System Impact Assessment Report

Wolfe Island Shoals Wind Generation Station

Final Report

CAA ID 2010-402

Figure 21: Absorbing 0.33 pu Reactive Power at Full Power Output.

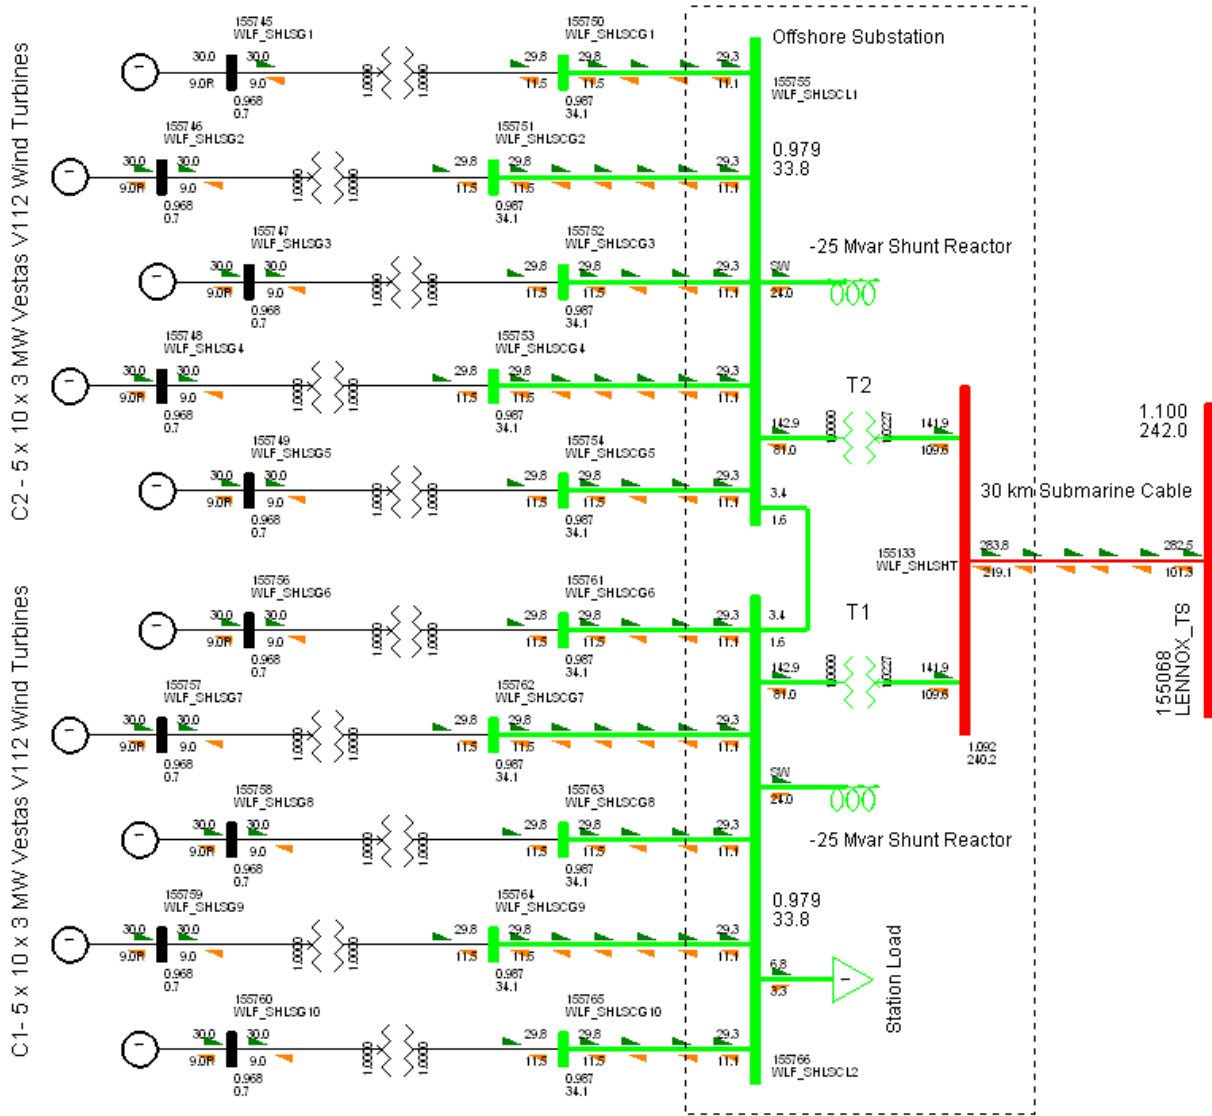
This study was done to demonstrate that while absorbing the required amount of reactive power at rated plant output, the continuous equipment ratings provided will be exceeded due to the charging current of the 230 kV cable. The cable is carrying 234 MW and 219 MVar, which is 363 MVA. At 240 kV, the load will be 870 Amps and the equipment is rated at 800 Amps. The 230 kV buses and equipment are rated at 400 Amps and they will carry 430 Amps under these conditions. The transformers are rated for the higher ONAF rating of 165 MVA and they would carry 178 MVA under these conditions.

- Confirm the reactive capability of the plant at full power output would not be limited because the duration of the circumstances described, would result in short term overload ratings being utilised
- Increase the thermal capacity of the equipment
- Curtail active power output to avoid overloading

Figure 22: MVar injection to IESO controlled grid at PCC with wind turbine reactive capability disconnected and 230 kV submarine cable in service.

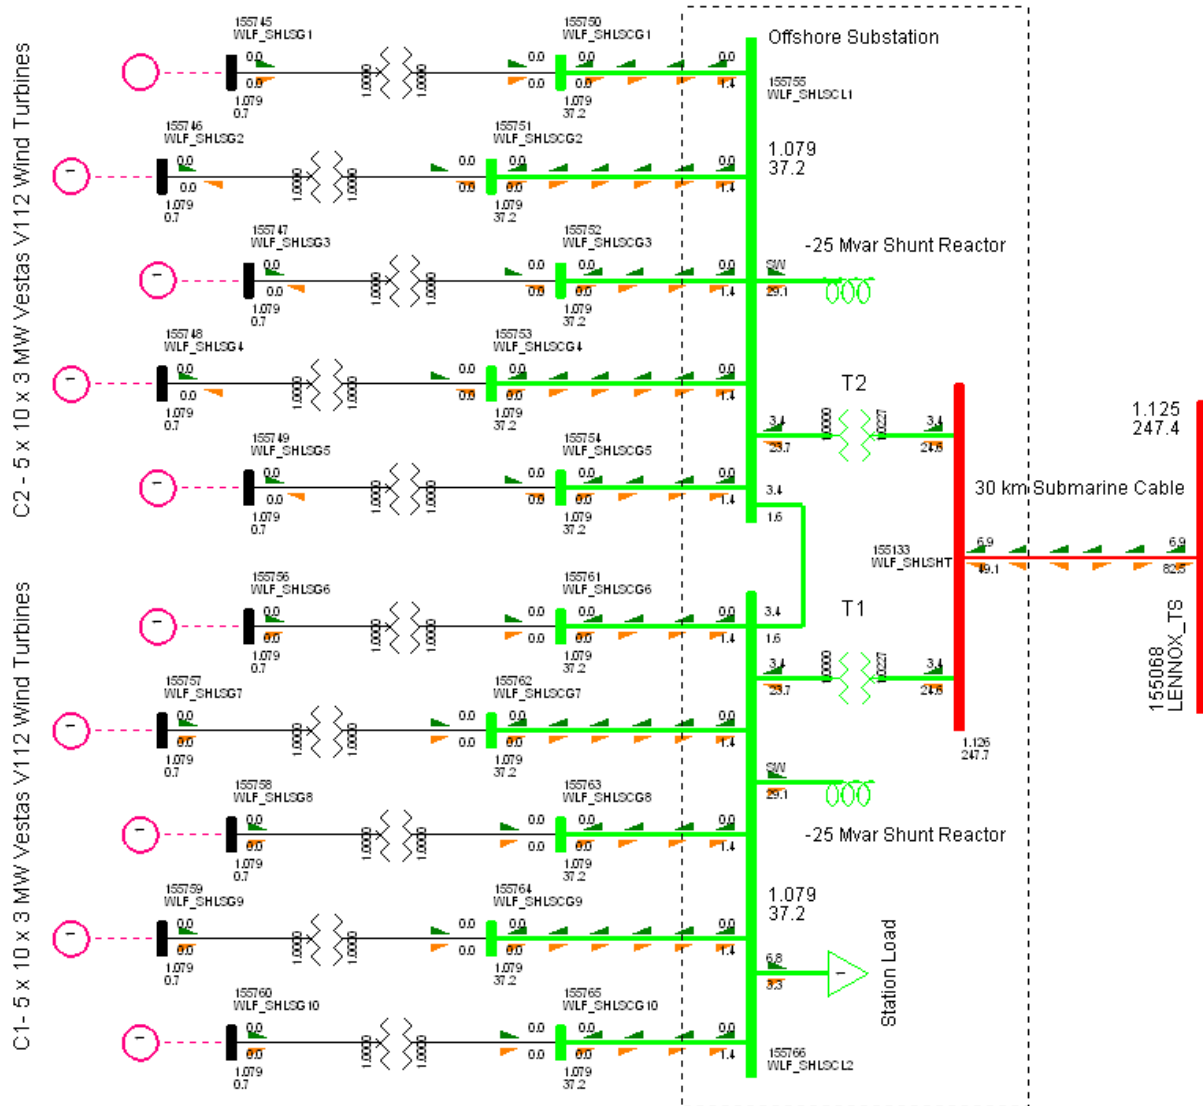
Figure 22 shows that with the –50 MVar of reactor banks in service, at conditions which leave the WTG plant unable to absorb reactive power, surplus MVar is generated at the point of connection. This subtracts from the output of existing reactors placed at Lennox TS and is not permissible at this part of the network, where high voltages are an issue.

Figure 1: Wolfe Island Shoals WF Connection at Lennox TS

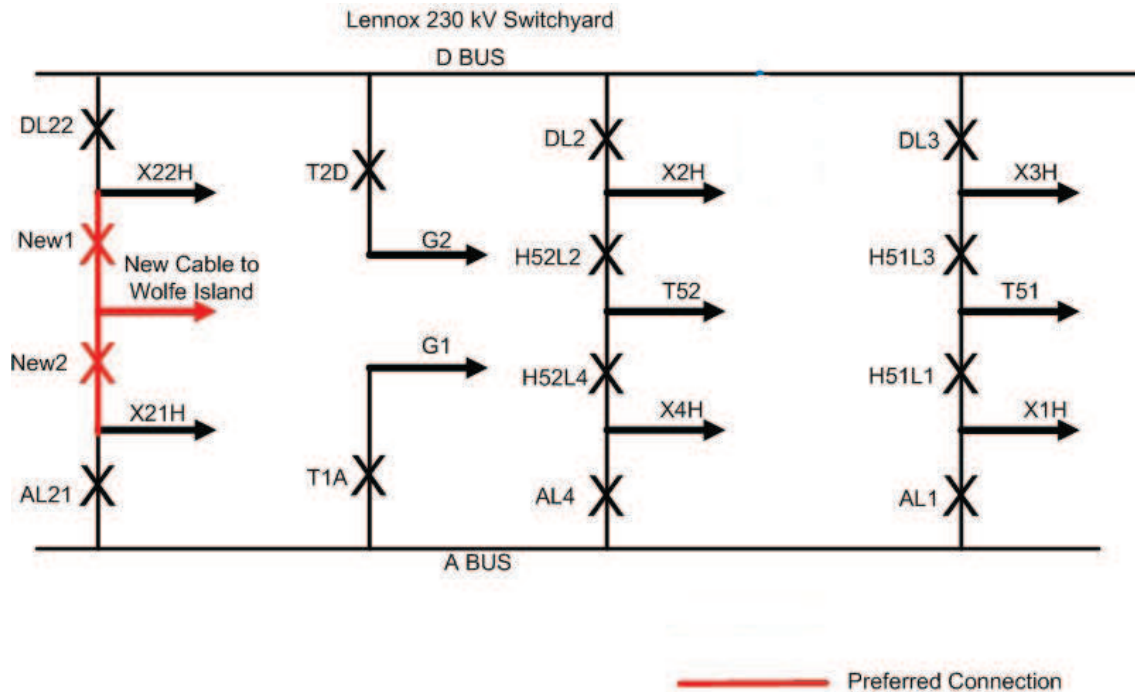
It is feasible for Wolfe Island Shoals Wind Farm to connect the proposed 300 MW generation at the location in Figure 1 as long as the proposed changes are made:

- Due to connection of the new Wolfe Island Shoals Wind Farm between the 230 kV A and D buses, two new 230 kV breakers along with dual microprocessor based breaker failure relays for each breaker are required. Breakers adjacent to the new breakers will have their existing electromechanical relays replaced by a microprocessor based relay. Existing 230 kV lines X21 and X22 protections will be revised to accommodate the new 230 kV breakers in the new diameter. New 'A' and 'B' line distance protections (including three phase CVTs) will be installed for the 230 kV line between Lennox TS and Wolfe Island Shoals Wind Farm.
